## ORIGINATION FORM

Proposed Revisions to a Standard Plans Index  
(Please provide all information — Incomplete forms will be returned)

Index Number: 700-040  
Sheet Number (s): 2 of 5  
Index Title: Cantilever Sign Structure

LAST REVISION 11/01/21	REVISION	DESCRIPTION:		FY 2022-23 STANDARD PLANS	CANTILEVER SIGN STRUCTURE	INDEX 700-040	SHEET 2 of 5
---------------------------	----------	--------------	--	------------------------------	---------------------------	------------------	-----------------

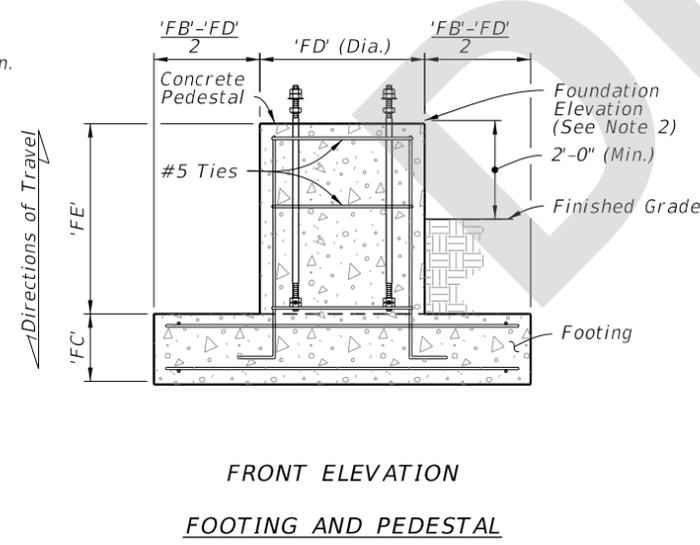
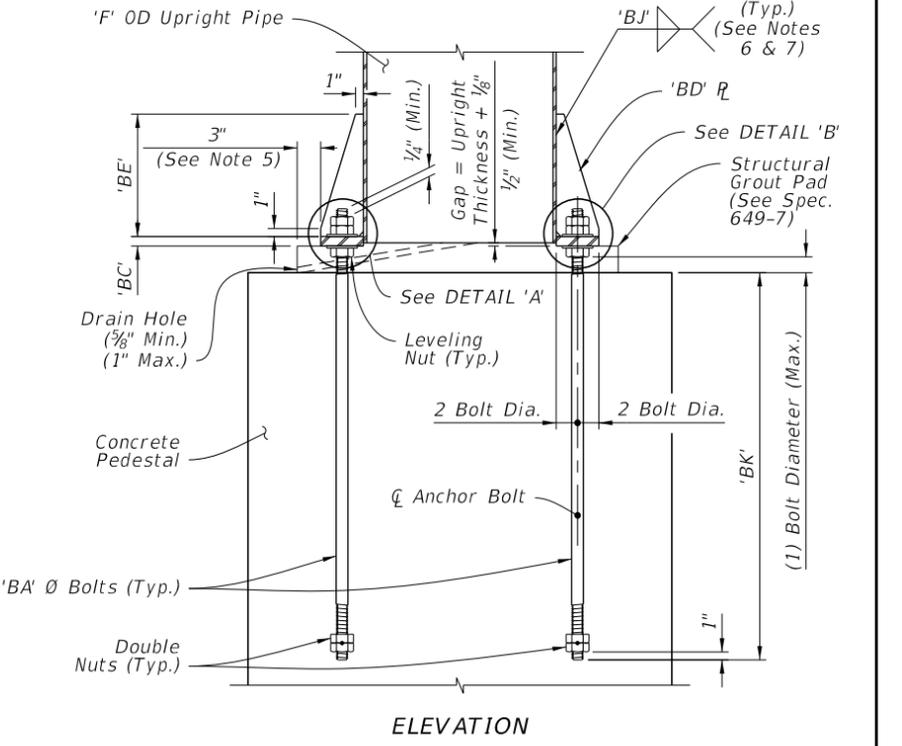
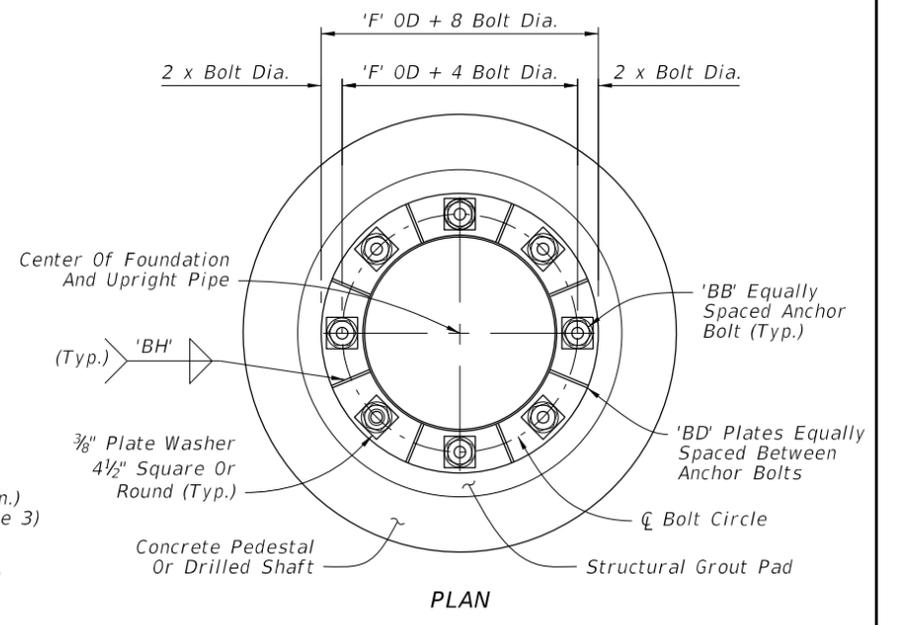
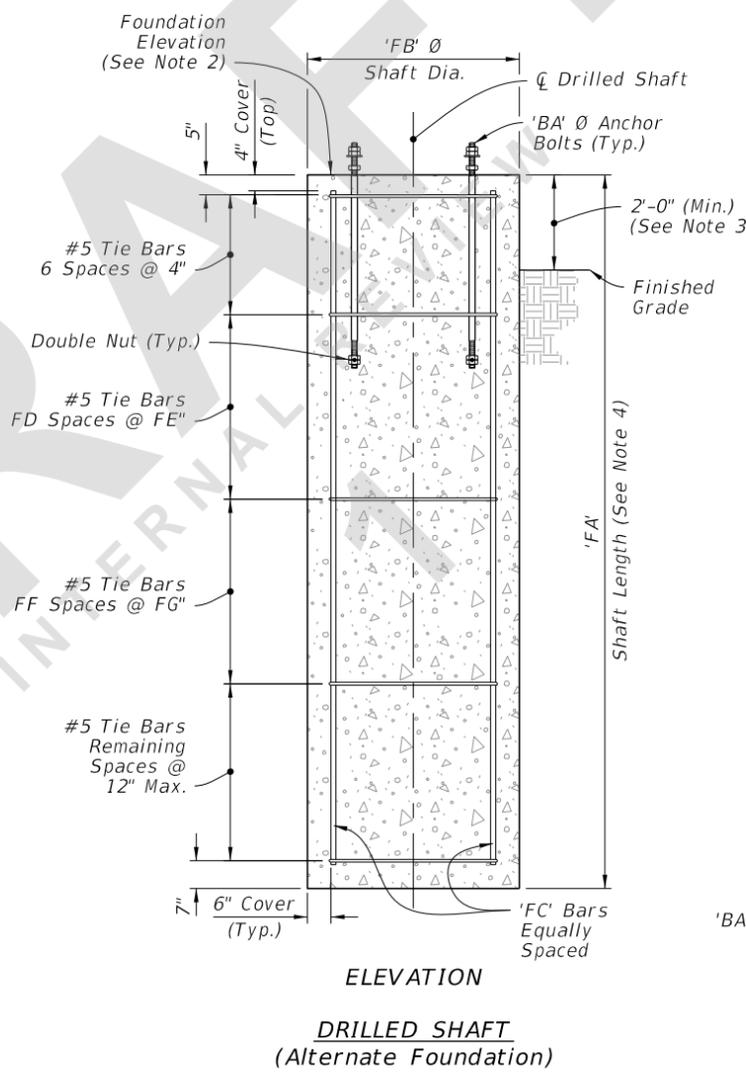
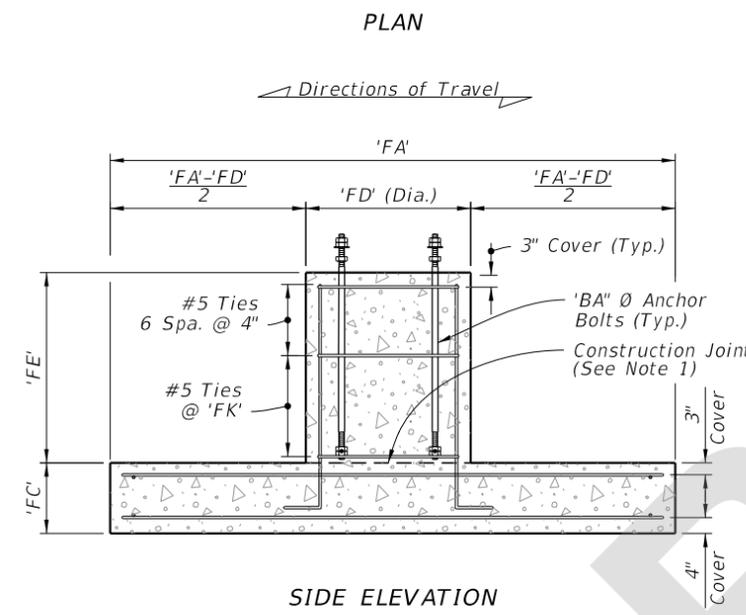
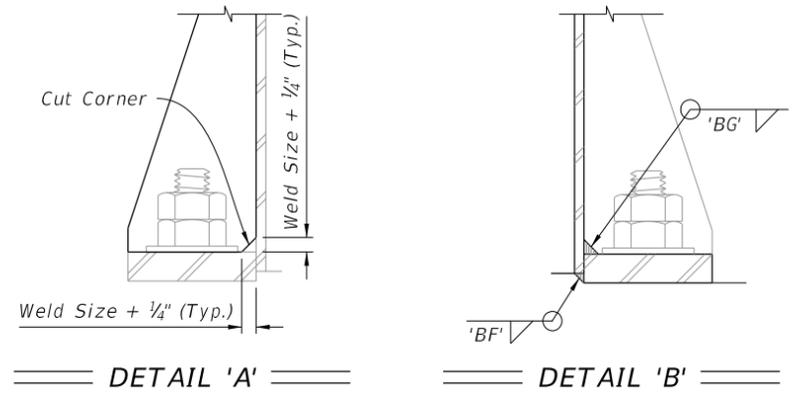
Sheet 2: Changed the 2'-2" lap splice for the #5 tie bars on the spread footing plan view to 1'-8".

The reference shown for longitudinal bars is incorrect.

Required lap length for #5 tie bars for spread footing shall be shorter rather than longer than what is required for drilled shaft (2'-0") due to higher concrete strength of spread footing.
